STATE OF NEBRASKA DEPARTMENT OF ROADS ADDENDUM NO. 1

PROJECT NO. EACSTPD-EACBR-92-5(105)

JCT. US-30 / N-92 NEAR CLARKS LETTING DATE: FEBRUARY 7, 2002

## TYPICAL DRIP PLATE DETAIL FOR EXTERIOR GIRDERS Not to Scale

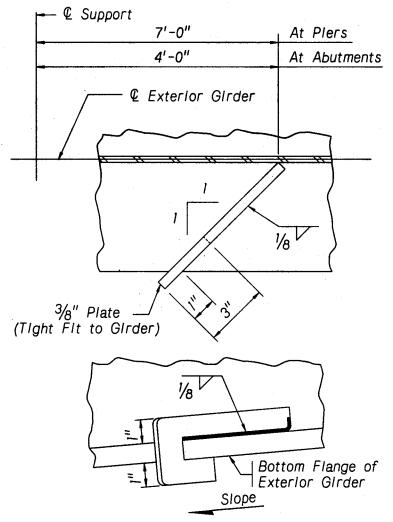
Plan sheet 43 is amended to include the following TYPICAL DRIP PLATE DETAIL FOR EXTERIOR GIRDERS:

Drip plates will be placed on the outside of the exterior girders at all supports.
